Access Compliance Report

Public Rights-of-Way

(Curb Ramps)

Intersection ID: 22303	Main Street: SHARON_VIEW_RD	Cross Street: GAYWIND_DR	Location: E
ADA ID: 0D0561A44C2B	Ramp Type: PerpDiag	Initial Pass/Fail: Fail	Overall Compliance: No
Severity Score: 12.5			
Codes/Mitigation Info/Possible Solution		Field Measurements/Component Compliance

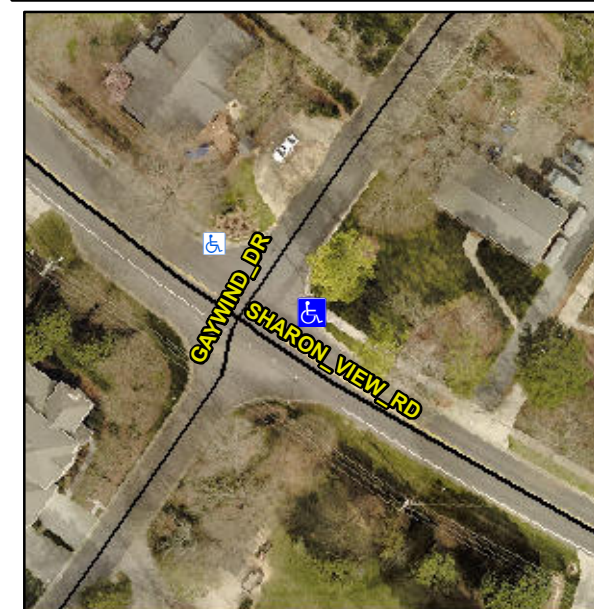
Not Found, R304.2.2

Compliance	Description	Data	Compliance	Description	Data
N/A	Ramp Length (in)	55.0	No	Ramp Slope (%)	8.9
Yes	Ramp Width (in)	48.0	Yes	Ramp XSlope (%)	1.8
N/A	Flare Type LT	N/A	N/A	Flare Type RT	N/A
N/A	Flare Slope LT (%)	N/A	N/A	Flare Slope RT (%)	N/A
N/A	Flare Traversable LT?	N/A	N/A	Flare Traversable RT?	N/A
N/A	Landing Length (in)	N/A	N/A	DWS Provided?	N/A
N/A	Landing Width (in)	N/A	N/A	DWS Contrast?	N/A
N/A	Landing Slope (%)	N/A	N/A	DWS Length (in)	N/A
N/A	Landing X Slope (%)	N/A	N/A	DWS Full Width?	N/A
N/A	Landing Curb? (Y/N)	N/A	N/A	DWS Offset (in)	N/A
N/A	Shared Landing?	N/A			
N/A	Gutter Ponding?	N/A	N/A	Gutter Slope (%)	N/A
N/A	Gutter Lip Ht (in)	N/A	N/A	Gutter X Slope (%)	N/A
N/A	Painted X Walk1?	No	N/A	Painted X Walk2?	No
	X Walk 1 Direction	To NW		X Walk 2 Direction	To SW
N/A	X Walk 1 Width (in)	N/A	N/A	X Walk 2 Width (in)	N/A
	X Walk 1 Slope (%)	3.9		X Walk 2 Slope (%)	7.2
	X Walk 1 X Slope (%)	5.6		X Walk 2 X Slope (%)	3.6

Remove & Replace Curb Ramp With Two New Directional Ramps or Equivalent.
